ADDRESS: 1504 PINE ST

Proposal: Stucco front facade; replace windows

Review Requested: Final Approval

Staff Contact: Ted Maust, Theodore.Maust@phila.gov

2 PINE ST ELEVATION - RESTORATION ELEVATION
1/4" = 1'-0"

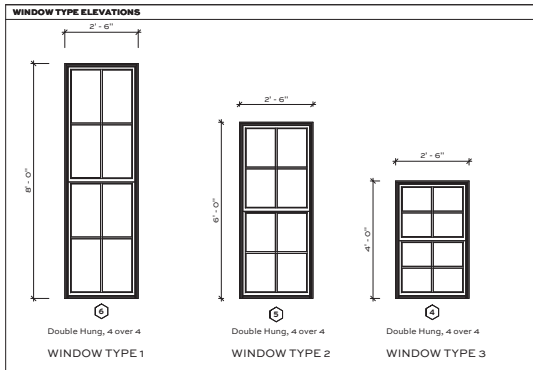
The applicants, new owners of the property, propose removing the older stucco and applying a thin layer of stucco over the entire façade, tooled with a simulated join pattern. They cite the stuccoed façade at 1514 Pine Street as a similar scope of work. The stucco work at 1514 and 1506 Pine Street pre-date the designation of this row. It is unclear exactly how thick the stucco coating would be. The proposed scope of work would likely result in removal of detail in the trim elements around the window openings in addition to the more elaborate ornament on the first and second floors, which is currently covered by the rusticated stucco.

The application also proposes replacing the windows on the front elevation. Elevation drawings suggest that the proposed replacements replicate the historic windows, with a thicker central muntin, but no section drawings have yet been submitted.

STAFF RECOMMENDATION: Denial, pursuant to Standards 5 and 6 and the Masonry Guidelines.
